Technical Bulletin

Subject: VWC Remanufactured 2.0l Air-Cooled Engine Group: 10

Number: 10-90 T01

Models(s): Type II/Vanagon 1975 - 83 MY Date: May 31, 1990

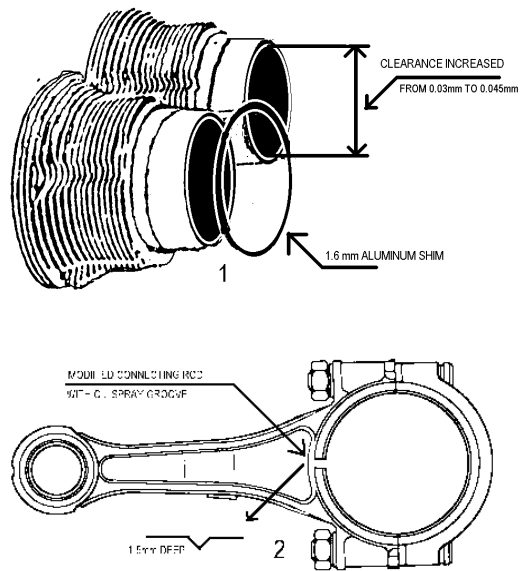
Engines, P/N 071 100 031AX, 039 100 031 B/C/DX, have been modified to improve heat transfer and increase durability. These changes affect Engine codes: GD, GE, CV. The following improvements have been introduced as of remanufactured Engine number 89000.

1. To eliminate seizing of pistons, increased piston/cylinder clearance from $0.03\text{mm} \pm 0.008\text{mm}$ to $0.045\text{mm} \pm 0.005\text{mm}$.
2. Eliminate aluminum seal 021 101 341A between cylinder and cylinder head.
3. Eliminate paper gasket 021 101 341A between foot of cylinder and crankcase.
4. Install 1.6mm aluminum shim 071 101 341, with adhesive D 000 400 at foot of cylinder to compensate for removed paper gasket and aluminum seal. Illustration 1.
5. To improve heat transfer, oil grooves on both sides of the connecting rod to allow oil splash to cool bottom of the piston. Illustration 2
